Fadel Residence

817 Alhambra Circle
Coral Gables, FL 33134
Folio #: 03-4108-001-5080

City Comments Revision Narrative

Board of Architects Review Comments. Date 04-30-2021

A 4.1

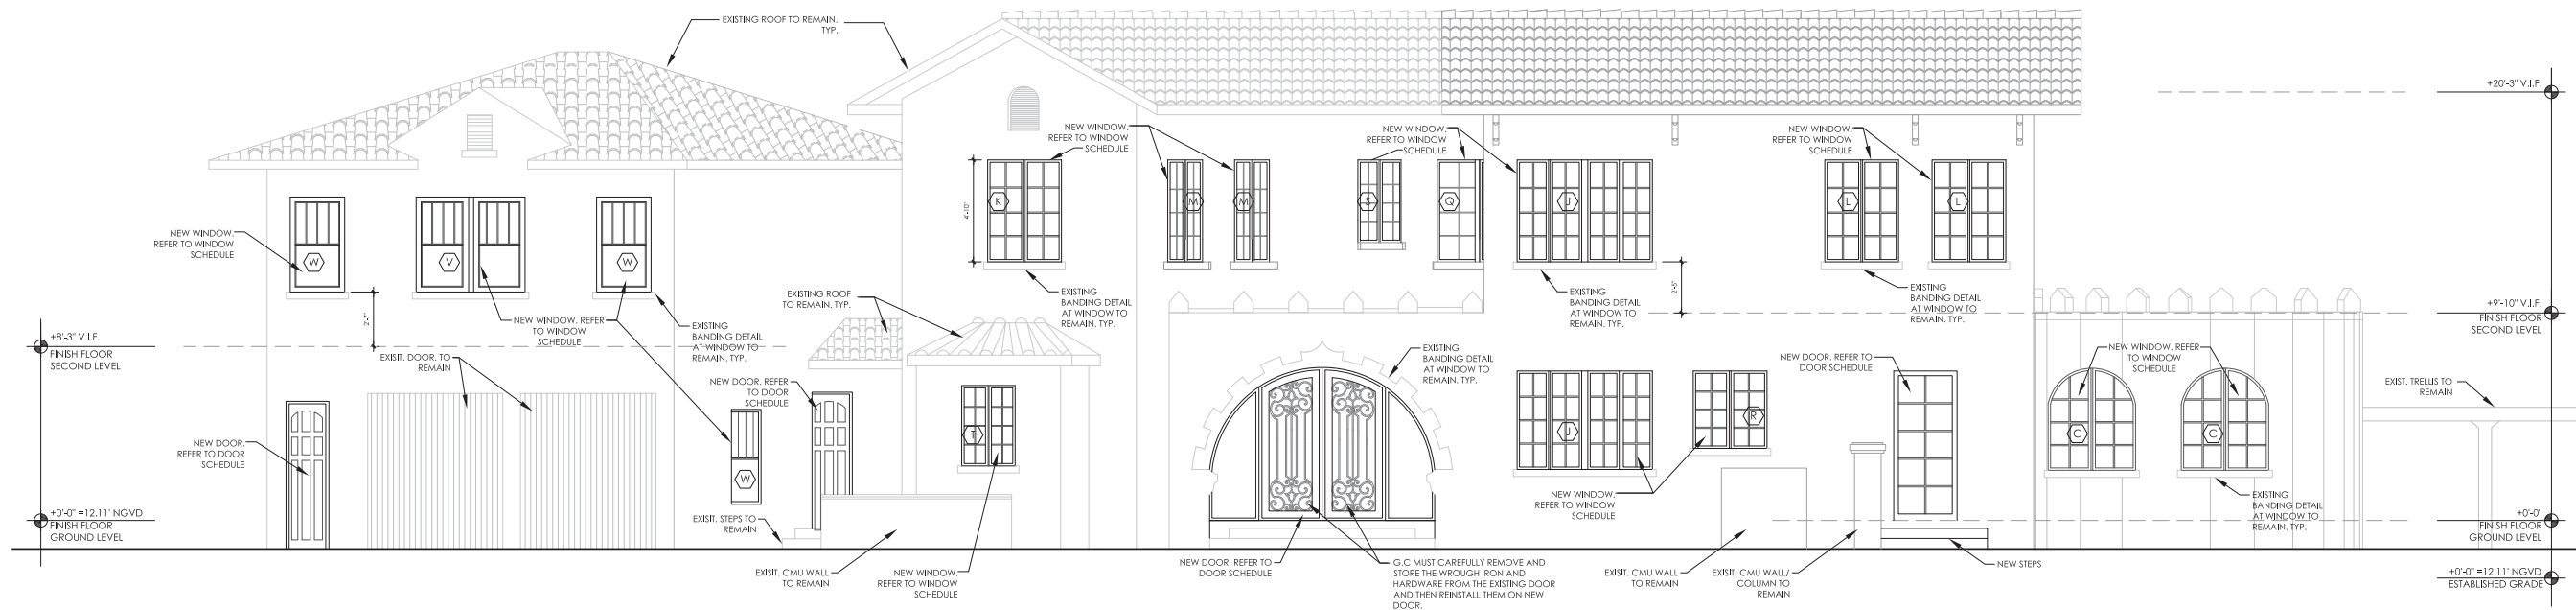
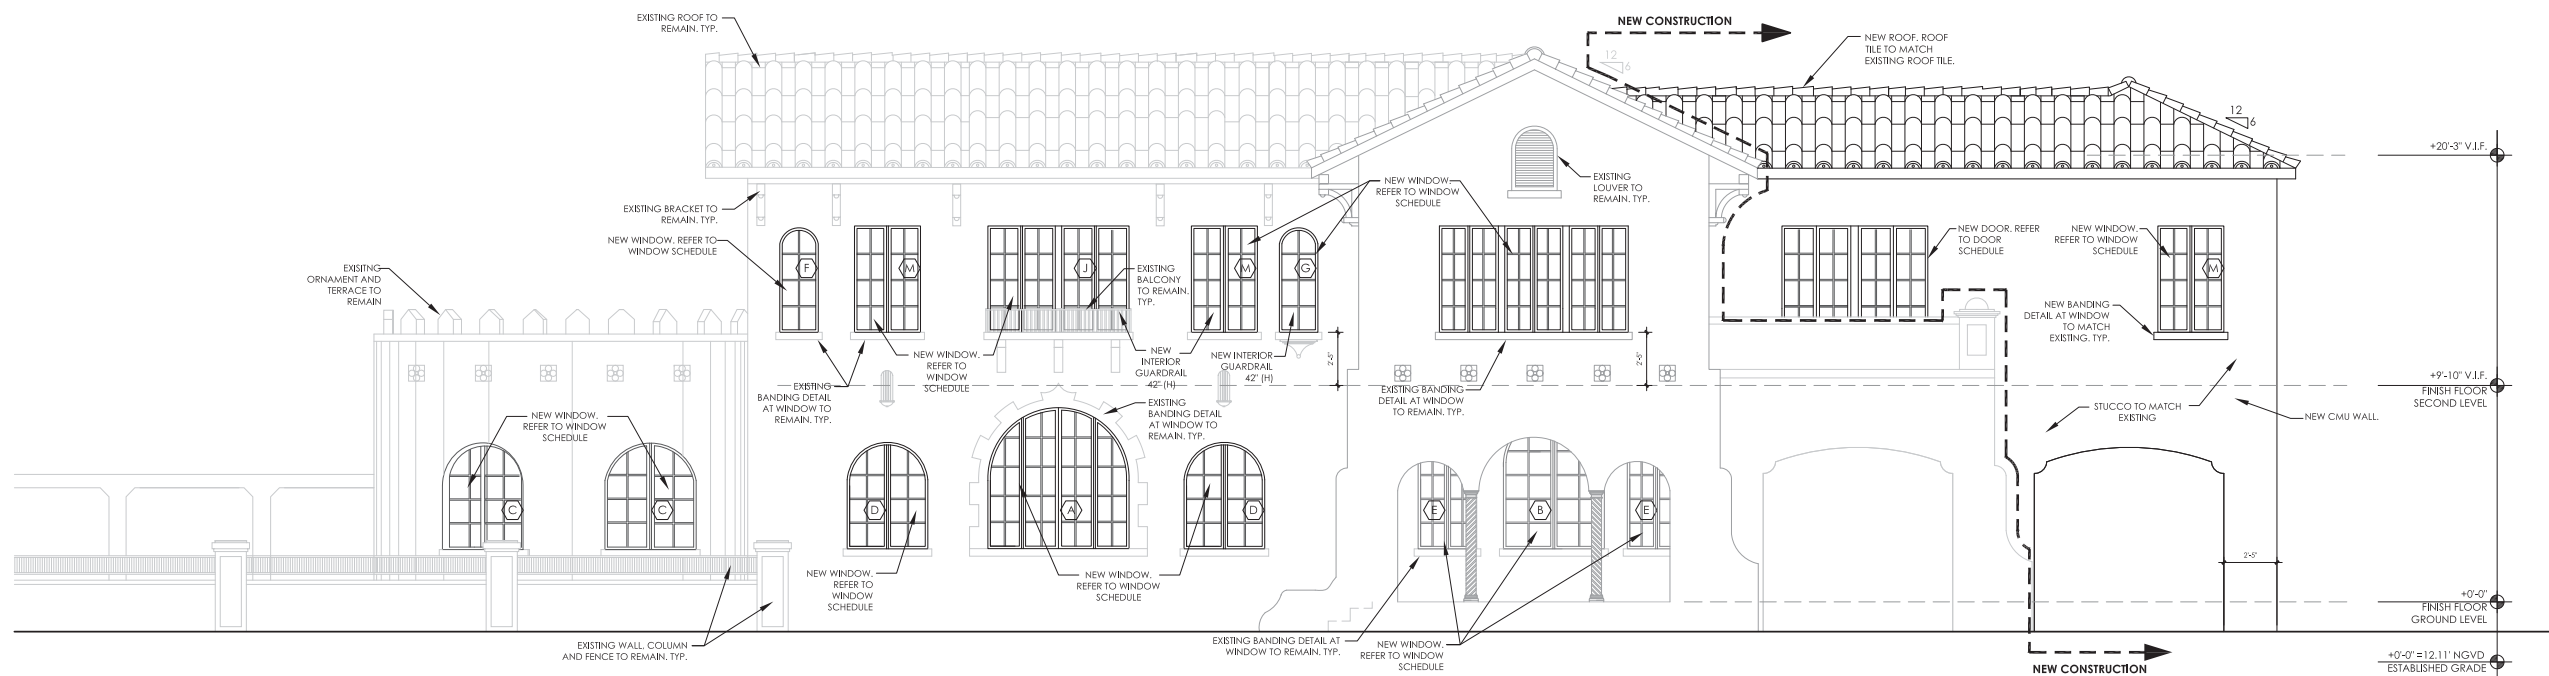
- 1) Incorporating the correct arch on the side of the carport to match the style of the front arch.
Response: Refer to revised sheet BOA - A4.2 showing the new arch design matching arch of South elevation.
- 2) Restudy the balcony support - either show how it terminates on the inner elevation side or eliminate it, but it needs to be consistent.
Response: Refer to revised sheet BOA - A4.3 with new balcony detail.
- 3) Restudy the driveway
Response: Refer to revised sheet BOA - AS1.0 where the driveway layout has been corrected.
- 4) Correct the drawing, placing the before and after drawings together;
Response: All drawings had been placed as per BOA requested.
- 5) Correct the graphics on the drawing.
Response: All drawings had been corrected graphically as per BOA requested.
